Item 4.**Development Application: 375 Glebe Point Road, Glebe - D/2018/1586**

File No.: D/2018/1586

Summary Recommendation: This proposal is recommended for refusal.

Figure 21: Front axonometric view illustrating height exceedance

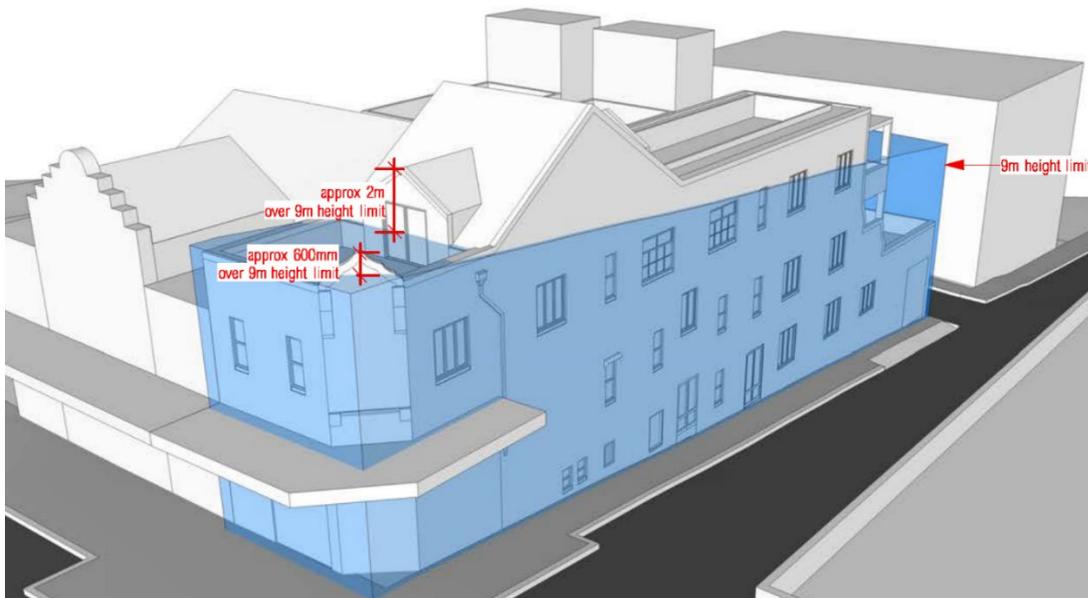
26. The site is subject to a maximum height control of 9m. The existing building exceeds this control and has a maximum height to the top of the roof parapet of 12.9m, which is a 43% variation of the control.
27. The proposed development results in works up to 12.1m in height, which is a 34% variation of the control. The front and rear dormers and the third level rear balcony exceed the height control.
28. Figures 21 and 22 below illustrate the built form of the existing building and proposed new works in relation to the 9m height control:

33. Whilst the applicant has addressed all of the required issues at Clause 4.6(3)(a) it has not adequately demonstrated that it is unreasonable or unnecessary to further contravene the control.

Whilst the existing building is over the height control, adding additional bulk above the height standard in a form that has adverse impacts on the significance of the item is not considered to be necessary or reasonable. Does the written request adequately address those issues at Clause 4.6(3)(b)?

Figure 22: rear axonometric view illustrating height exceedance

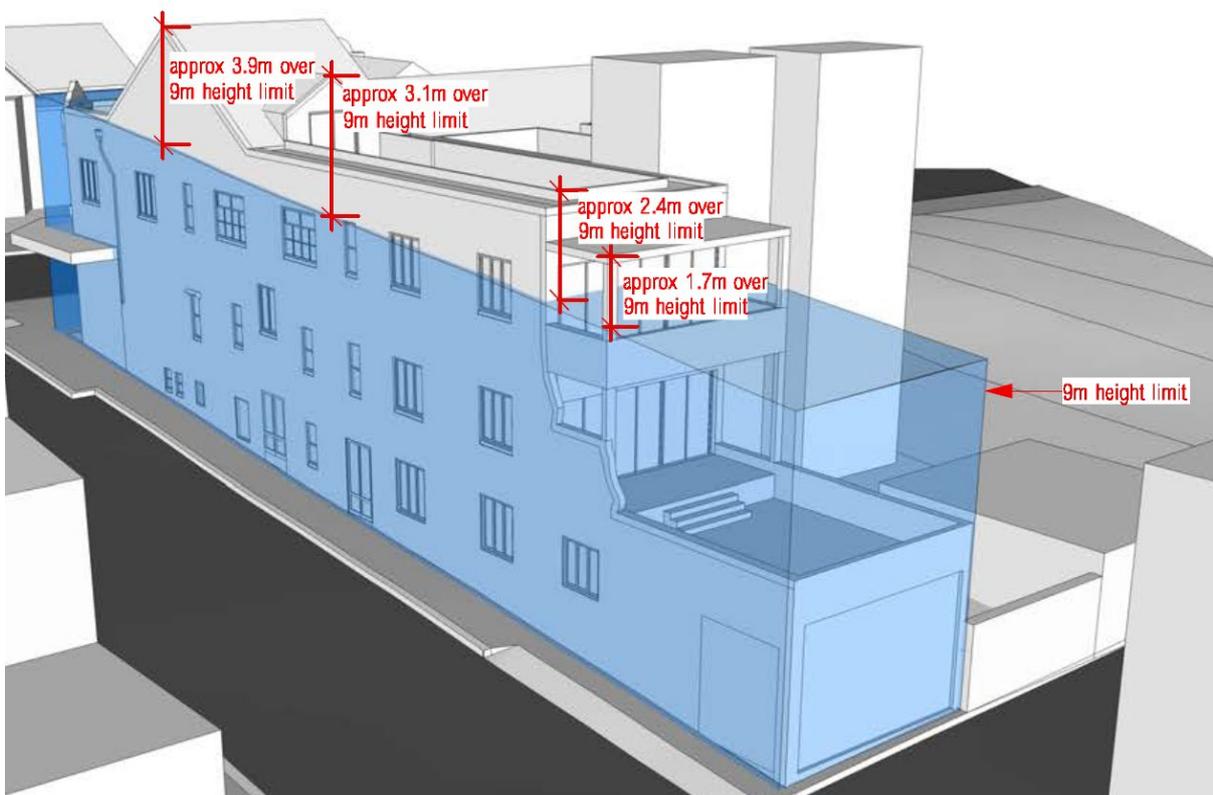
- 34. The written request has not adequately demonstrated that there are sufficient environmental planning grounds to justify contravening the standard as proposed.
- 35. The proposal will result in unsympathetic alterations and additions to a heritage item located within a conservation area. The extent of the additions to the heritage item, in particular the front and rear dormers comprised of aluminium framed doors, rather than timber framed windows, will have an adverse impact on the heritage significance of the building and conservation area. The extensive glazed openings are uncharacteristic of the building and conservation area. The design and heritage impacts of the proposal are discussed further elsewhere in this report.

Figure 24: Illustrating extensive new glazed openings, glass balustrades, and impact to side horizontal parapet wall on the south elevation (bubbled).

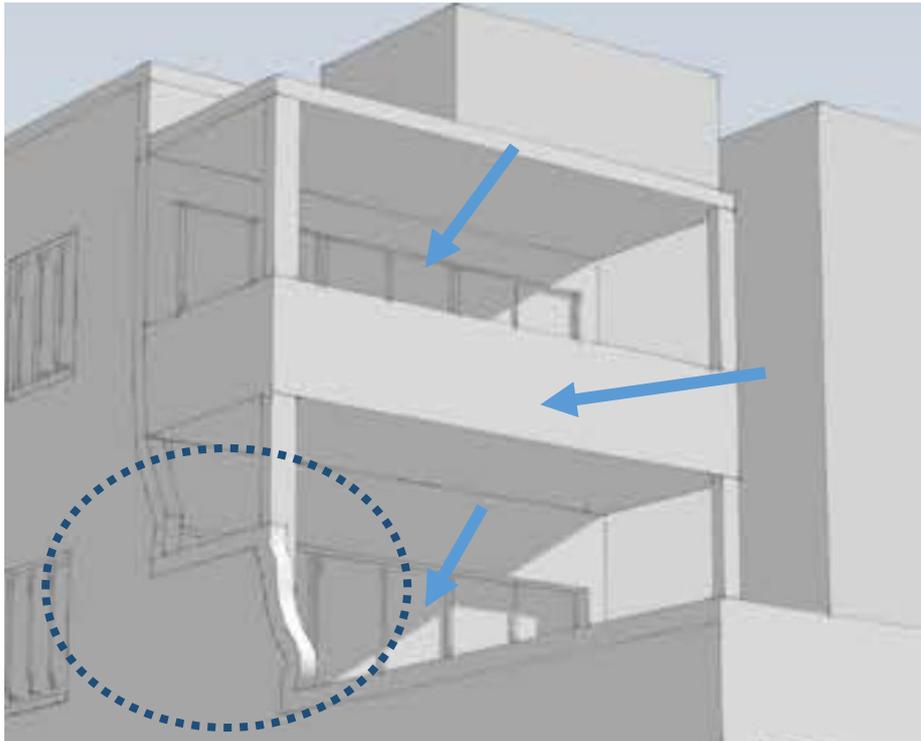
- (c) The new balcony to apartment 3 including wall removal to provide new full width aluminium framed doors and balcony with glass balustrades. This element will have an adverse impact as it will result in the loss of two sets of early windows. The extent of the glazed openings and glass balustrades is out of character with the building and will be visually prominent from the streetscape.
- (d) The new balcony to apartment 2 including wall removal to provide new full width aluminium framed sliding doors will provide adverse impact, particularly with the extent of the wall removal and extensive new glazed openings. The new awning to the balcony will impact the side horizontal parapet wall on the south elevation

Figure 25: illustrating 4 storey form

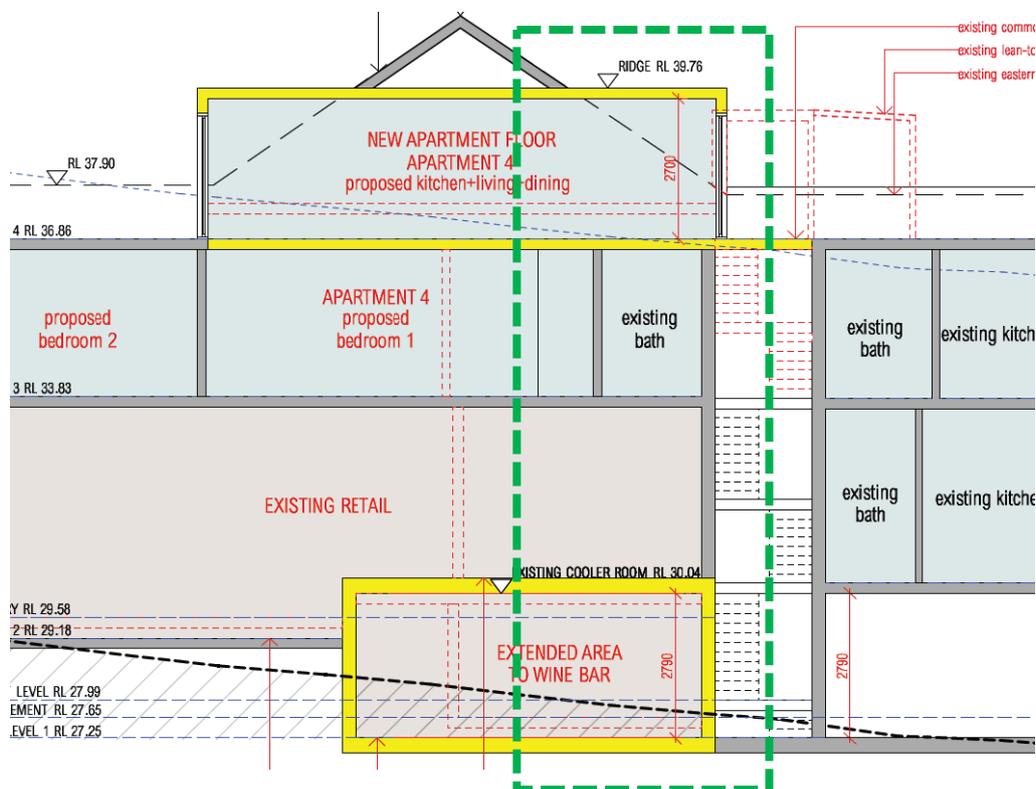
69. The subject site is identified as a 2 storey character area in accordance with the height in storeys map in the Sydney Development Control Plan 2012.
70. The existing building presents as a 2 storey building to Glebe Point Road and a 3 storey building to Forsyth Street and Charlton Way. The proposal will further exacerbate this non-compliance.
71. The proposal includes the addition of front and rear dormers and lowering of the existing ceiling to provide an additional level (level 4) to the residential accommodation. The proposal includes lowering of the existing basement floor and additional excavation (level 1) to the commercial space.

72. The proposal is inconsistent with the objectives and provisions of Section 4.2.1 Building height in the Sydney Development Control Plan 2012.
73. The additional height exceedance does not reinforce the existing and desired neighbourhood character and does not retain or conserve the principle building form.
74. The additional height exceedance will be highly visible from Glebe Point Road, Forsyth Street and Charlton Way, further detracting from the significance of the conservation area and streetscape.

Figure 26: Illustrating level 2 rear balcony

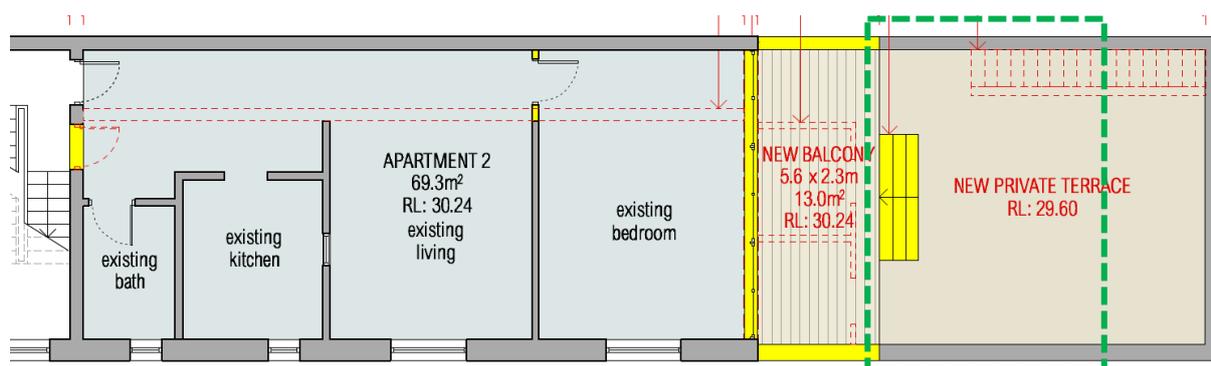
79. The proposed development includes a new balcony area to the rear of level 2 and 3 accessed from apartment 2 and 3, a new front rooftop terrace accessed from the front dormer of apartment 4, and a rear rooftop terrace accessed from the rear dormer of apartment 4.
80. Refer to the Figures below.

81. The new balcony/terrace areas adversely impact on overlooking and visual privacy to adjoining residential properties.
82. Whilst a form of privacy treatment to the rear balconies on levels 2 and 3 may alleviate the overlooking impact, and could potentially be supported, this has not been demonstrated with the proposal.

Figure 28: Illustrating level 4 front and rear balconies

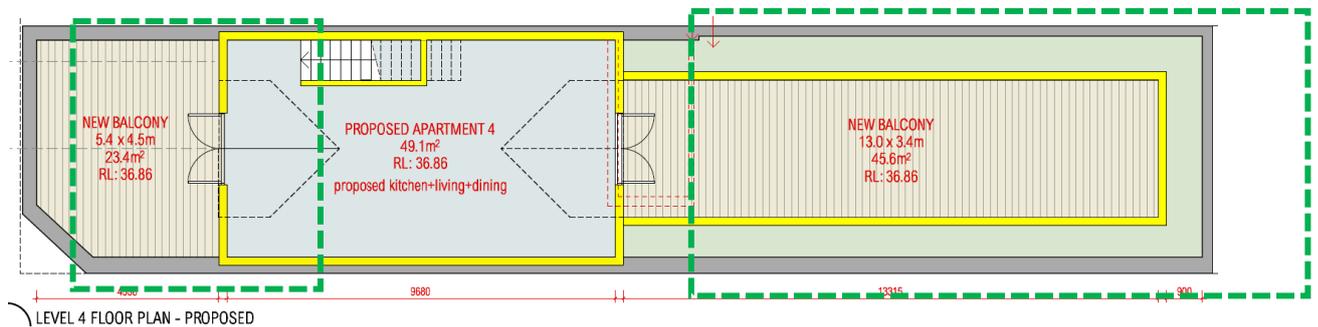
84. Privacy screening to the rooftop balconies would not be supported as it would further increase the bulk of the building and heritage impacts. Additionally, allowing a rooftop balcony presents opportunity for additional structures, such as sun shading devices, to be erected on the roof. The rooftop balconies provide for a significant breach of the LEP height control and is not supported.

Figure 29: illustrating the removal of the existing common corridor that provides access to waste storage for all three residential units.

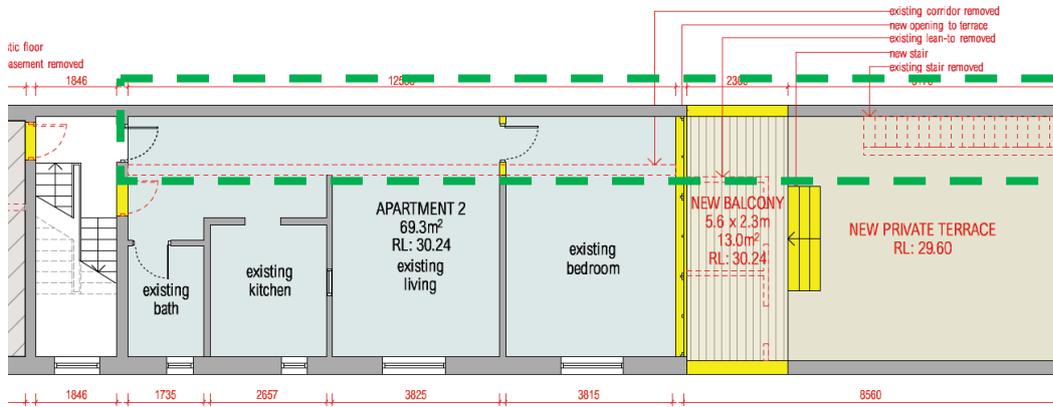
85. The proposed development presents concerns with waste and recycling management and the application has not adequately demonstrated compliance with Section 3.14 and Section 4.2.6 of Sydney Development Control Plan 2012 and the City of Sydney Guidelines for Waste Management in New Development.
86. The existing residential waste storage area is located on the level 2 terrace accessed through a common area corridor. The proposed works include removal of the corridor wall resulting in sole use of the terrace area for apartment 2. No additional waste storage areas have been proposed for apartment 3 and apartment 4.

87. The absence of common waste storage area for the residential units presents issues with accessibility to a waste storage area and a clear path of travel to the street for collection. Waste bins stored on the street or balcony areas are not supported.
